¹⁰¹
End to 8-26-82
memo to Knapf.

COMPARISON OF MODEL STUDIES:

THE HANFORD RESERVATION

By Linda L. Lehman and Ellen J. Quinn

**Figure 3. Plan View of Pasco Basin Rockwell Finite Element Grid
(After, RHO-BWI-LD-44)**

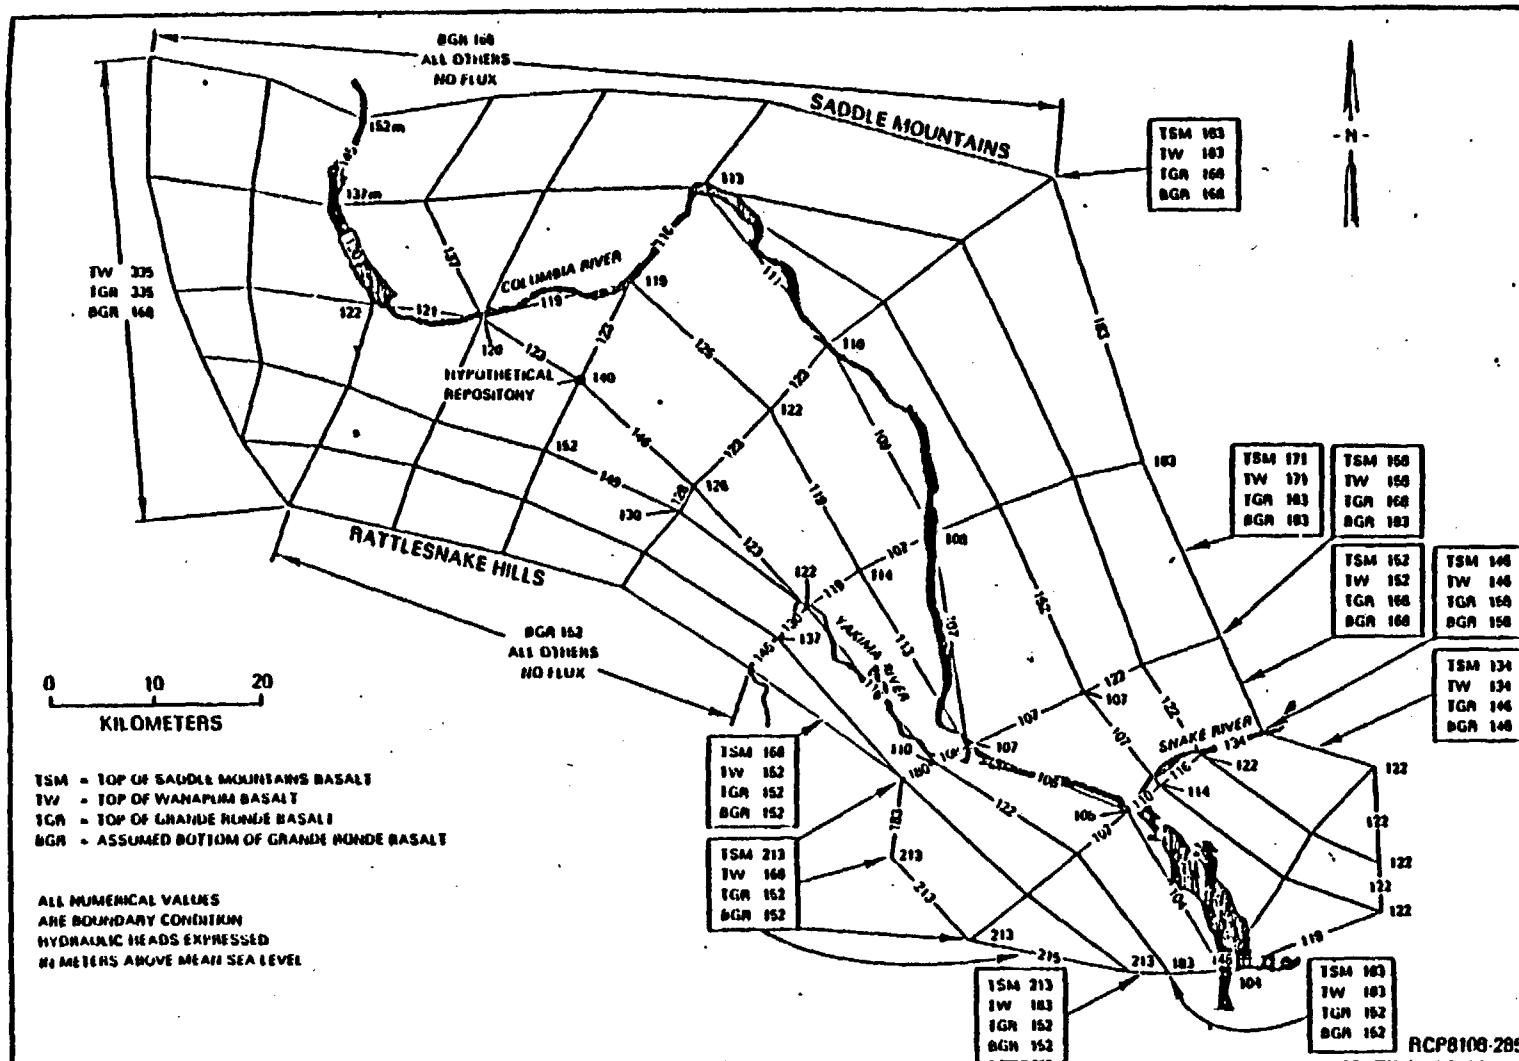
Figure 3 shows the plan view of the Pasco Basin grid network used by RHO in their simulation. All numerical values are boundary conditions expressed as hydraulic head in meters above mean sea level. Along the eastern boundary a recharge condition exists in the conceptual model (as shown on Figure 2 but head values used for this boundary in the simulation indicate either horizontal flow (head constant with depth) or discharge (head increasing with depth)). Since a recharge condition is not simulated, water flows out or rather than into the basin along that boundary. Conversely, the southeastern corner of the conceptual model is designated as a discharge area as shown in Figure 2; but in the numerical model heads either are constant with depth or decrease with depth as is typical of recharge head distributions. These inconsistencies in the formulation of boundary conditions have resulted in a lack of discharge in the modeled area for Rockwell's simulations.

Additionally, Rockwell has forced the water table to maintain a specific configuration through the use of constant head boundaries.

Figure 24. Major Areas of Model Input Disagreement (Northwest Pasco Basin)

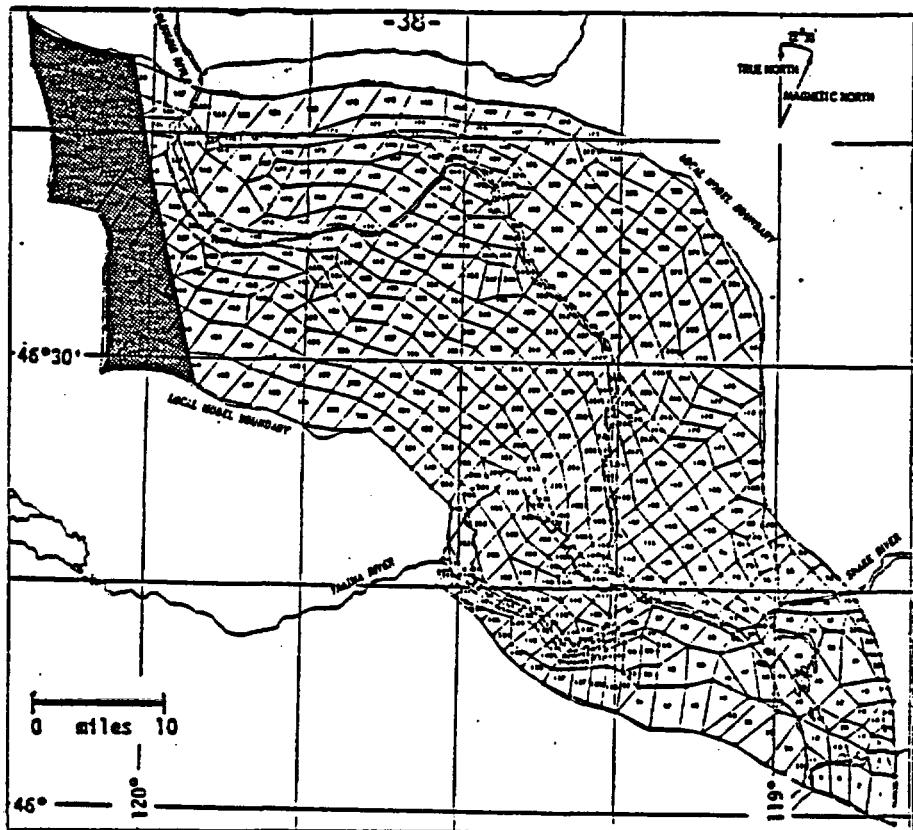
1. The Rockwell model used a recharge boundary condition along the northwest corner of the grid for approximately 25 miles (Figure 24). The pressure head (1,099 feet above sea level) was significantly higher than anywhere else in the model. This value, in fact, is so high that it caused all water to flow away from this area, across the basin, and out the eastern boundary. The eastward flow of water was exactly opposite to that of flow in the PNL model which depicted a westward and upward flow component.

PNL chose a no flow boundary condition along the same 25 mile area *.

Figure 25. Major Areas of Model Input Disagreement (Northern Pasco Basin)

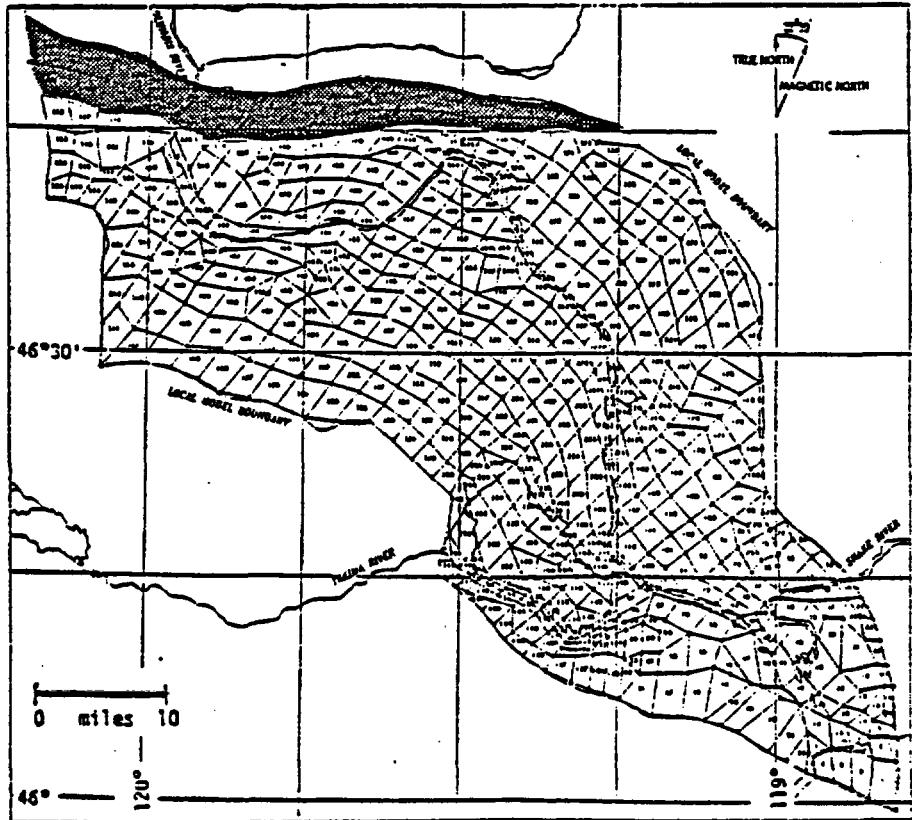
2. Rockwell set the head at the bottom of the Grande Ronde at 550 feet above sea level for approximately 42 miles along the northern basin boundary. No flow conditions were assigned to

the northern boundaries of all units above this; thereby preventing flow from entering the basin from the north (see Figure 25).

PNL assigned a flow boundary along this area. Head values ranged from 675 to 880 ft. above sea level - increasing to the east. No-flow boundaries were assigned to the Saddle Mountains Formation only. The head difference between the two models ranged from 125 ft to 330 ft.*

Figure 26. Major Areas of Model Input Disagreement (Eastern Pasco Basin)

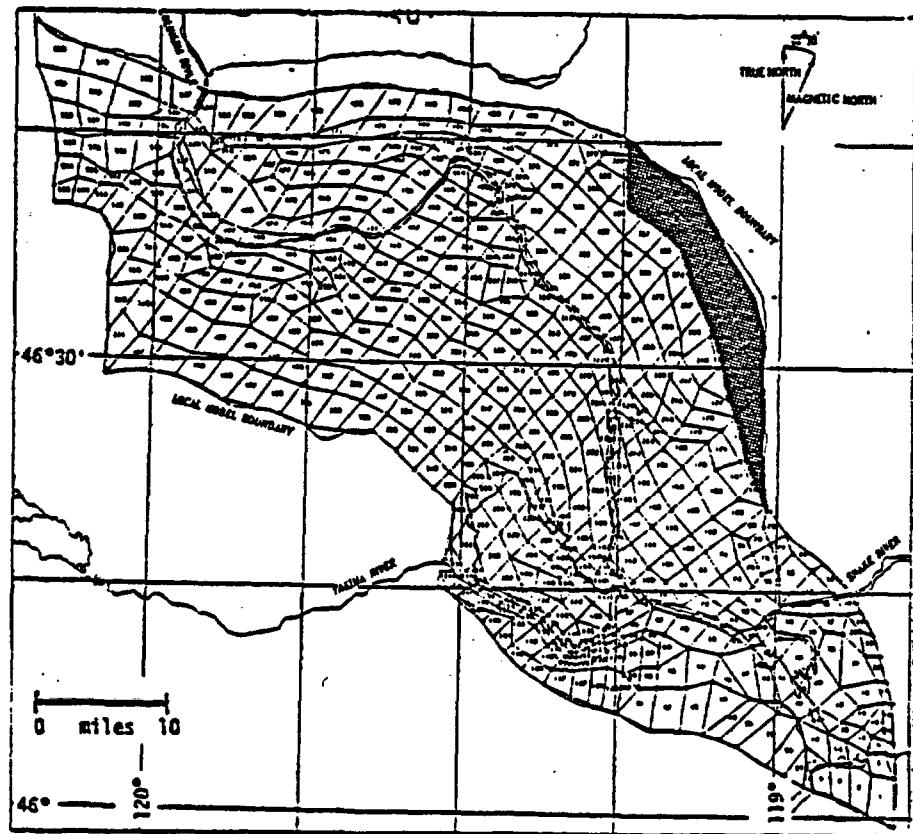
3. The eastern basin boundary of the RHO model, from the northern edge for approximately 25 miles southeastward, was set at 600 ft; and was considered to be at hydrostatic equilibrium (head constant with depth, i.e., flow is horizontal along the boundary) (see Figure 26).

The PNL heads along the eastern boundary, ranged from approximately 700 ft to 1100 ft above sea level-creating a head difference that ranged from 100-500 ft between the two models. Also, the PNL boundaries were recharge areas, i.e., head decreased with depth. It should be noted that in the PNL model the highest heads occurred in this area.

Figure 27. Major Areas of Model Input Disagreement (Southeastern Pasco Basin)

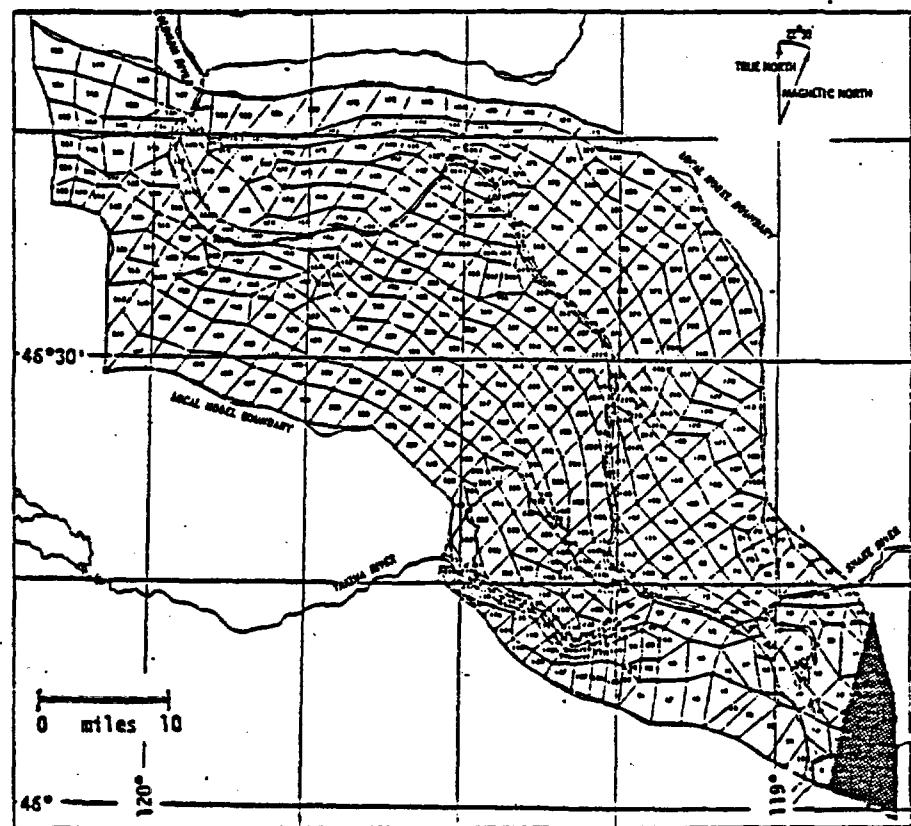
4. In the RHO model, for approximately 12 miles along the southeastern corner to Wallula Gap, heads were set at approximately 400 ft, again with the hydrostatic equilibrium assumption horizontal flow along boundary (see Figure 27).

In the PNL model this area was a discharge boundary with heads in the lower units set at 650 feet and at the upper units 437 ft.

The head differences between the two models result in a discrepancy of approximately 250 ft in the lower units. Since the RHO model does not permit an upward gradient in this area, no upward flow can exist. This accounts for to RHO's conclusion that particles do not leave the Grande Ronde formation. The boundary conditions prevent particles from leaving the Grande Ronde.

Figure 28. Major Areas of Model Input Disagreement (Southwestern Pasco Basin)

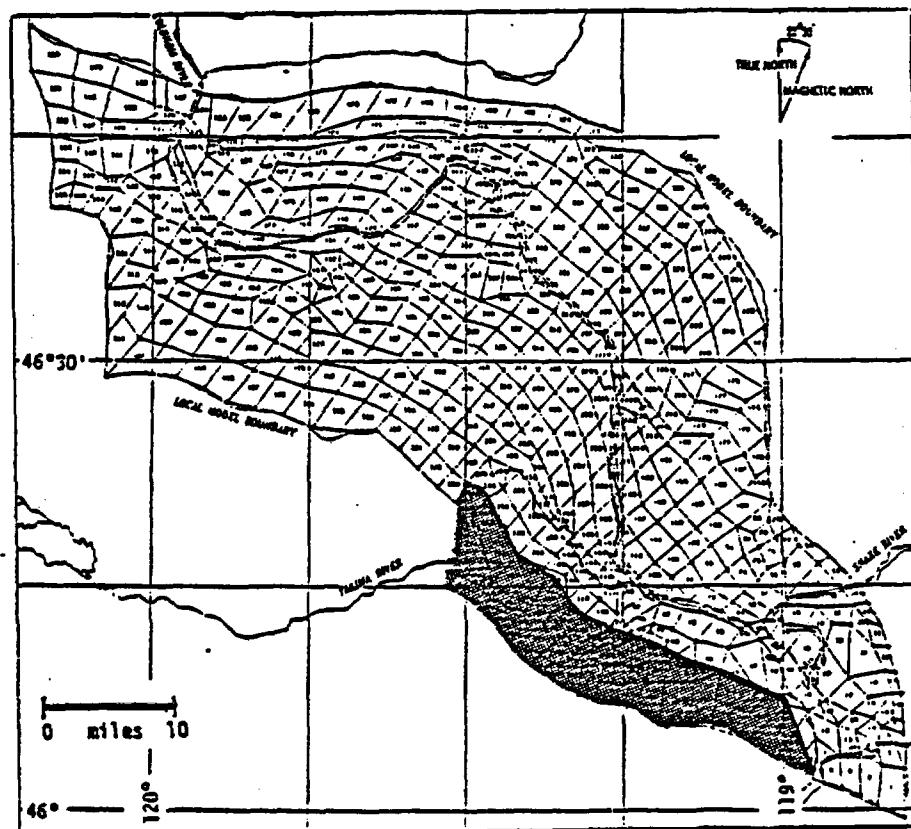
5. In the RHO model, in the area beginning immediately west of Wallula Gap and continuing clockwise around the southwestern boundary for approximately 30 miles, a recharge boundary condition was imposed. Heads in this area drop from 700 ft in the upper units to 500 ft in the lower units. The gradient imposed in this region influences the flow of water in the entire southeastern portion of the model. The recharge boundary forces water downward in the Wallula Gap area, instead of upward as would be expected in a discharge area. (Figure 28).

The PNL model assumed a no flow boundary condition along this same stretch.

Figure 31. NRC Particle Tracking Results with RHO Boundary Conditions
Plan View

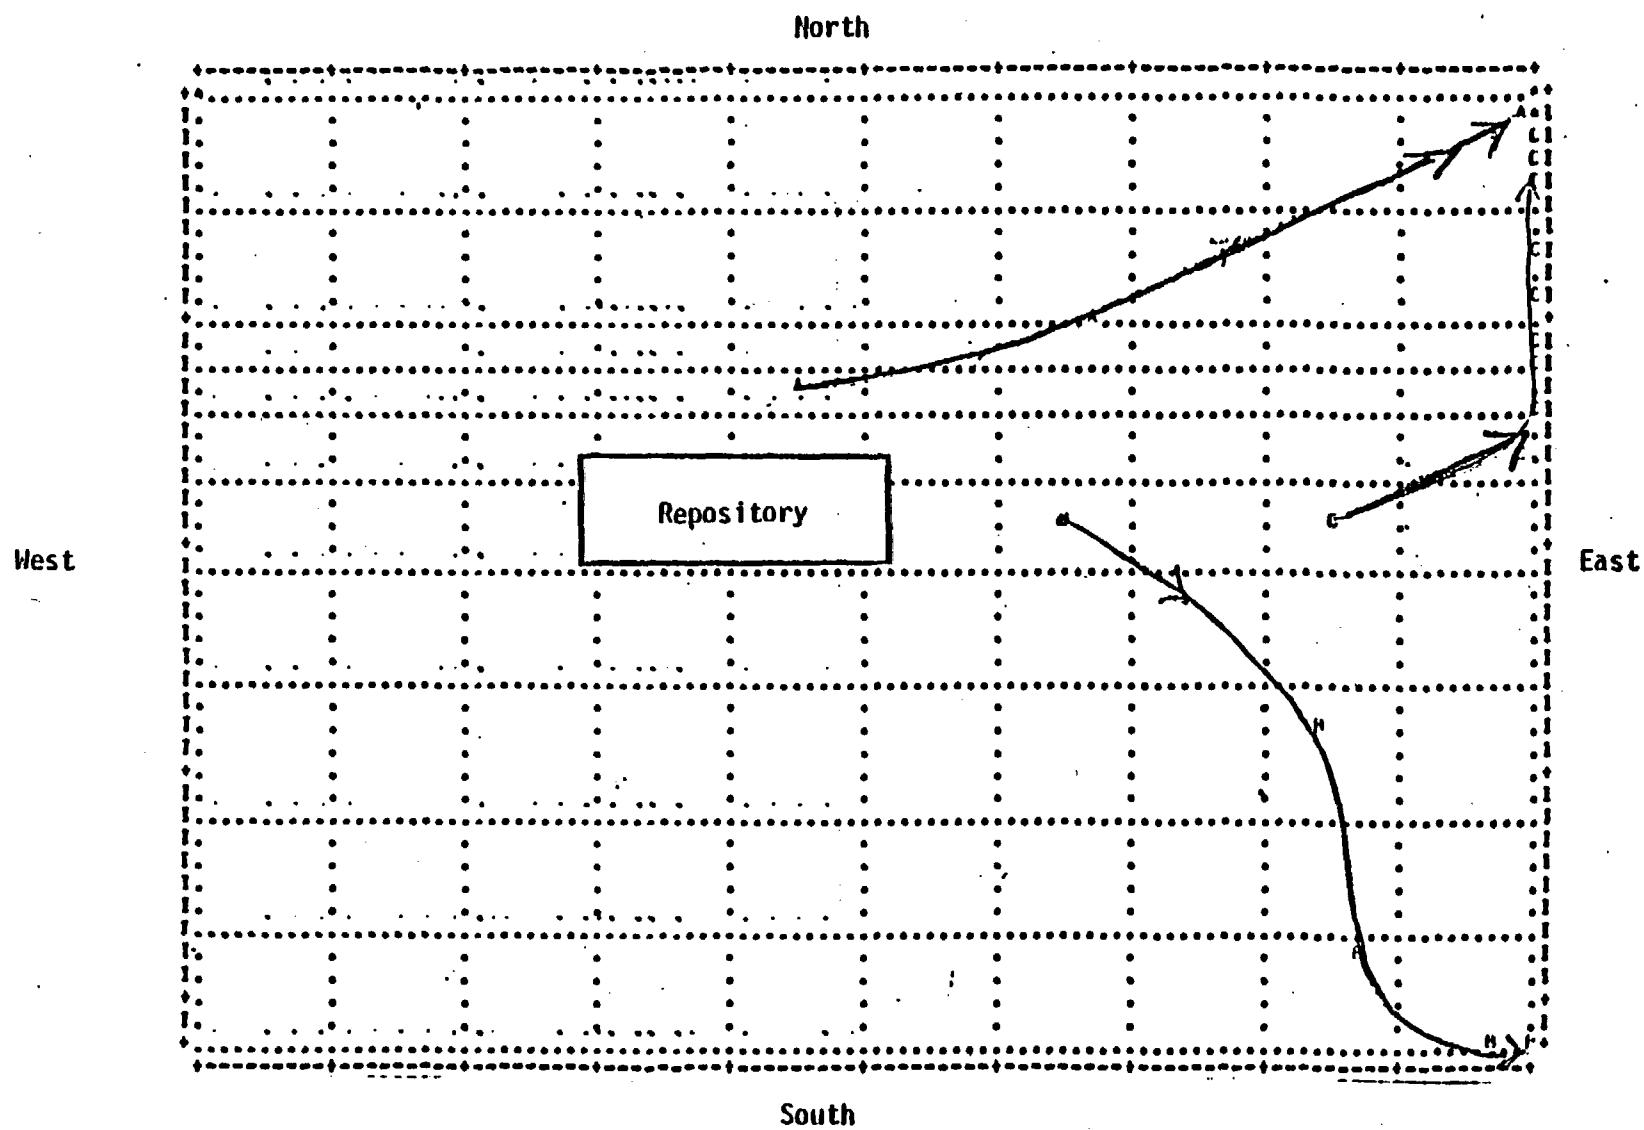
The output of the NRC computer runs were particle tracking plots and pressure contours. Figure 31 shows that particles released east of the repository will follow RHO's stream line. Therefore RHO's results were successfully duplicated using their pressure boundary conditions on a

different computer grid. This at first appears to substantiate the RHO conceptual model. However, RHO does not discuss in RHO-BWI-LD-44 what happened to particles released elsewhere around the repository. In the NRC simulation, most particles released in the vicinity of the repository actually moved either north or across the Columbia River and moved through the eastern basin boundary. While this characteristic is in complete harmony with the boundary conditions set in RHO's computer model, it is in direct conflict with RHO's conceptual model - which specifies recharge, not discharge, through the eastern boundary.

Figure 32. NRC Particle Tracking Results with R/HO Boundary Conditions
East - West Cross-Sectional View

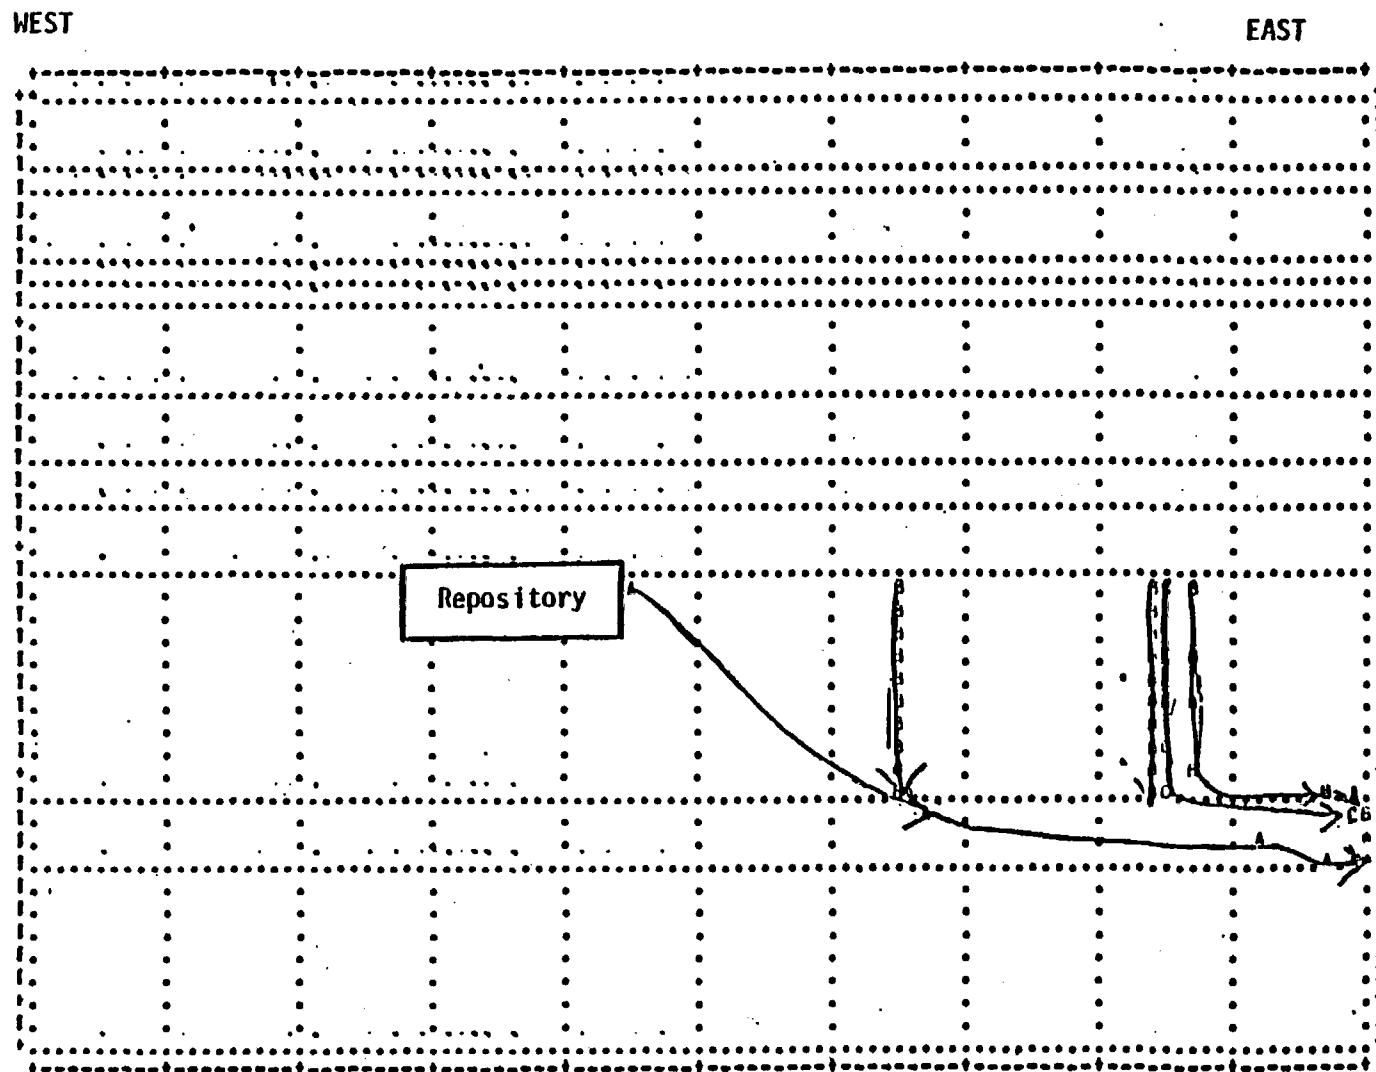
Additionally, the conceptual model clearly allows for vertical discharge in the southeastern part of the basin, the Wallula Gap area. The head distributions chosen in the numerical model are not consistent with the conceptual model and do not allow upward discharge to occur (Figure 28). Instead, particles in the vicinity of Wallula Gap were actually forced downward by the applied pressures. (Figure 32).

Figure 36. Areas of Divergent Opinion Regarding Boundary Conditions

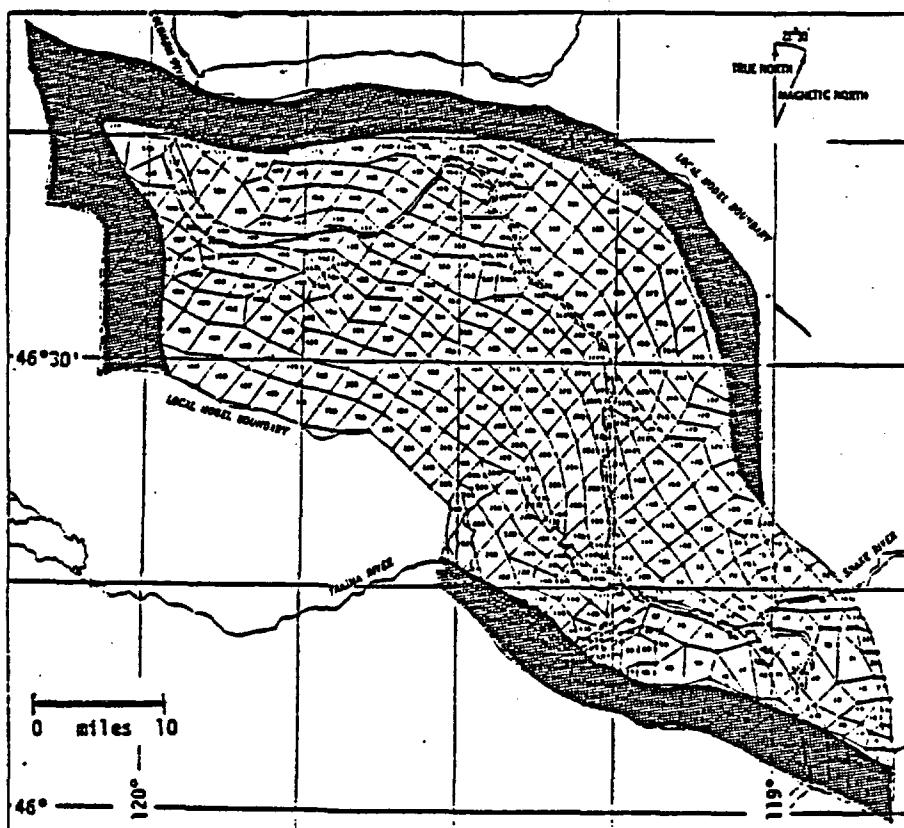
western and southeastern boundaries (Figures 24 and 28). Additional analyses will be required to determine the individual importance of these bounds. These areas, Figure 36, are recommended for future study to obtain agreement on the real hydraulic head configurations.
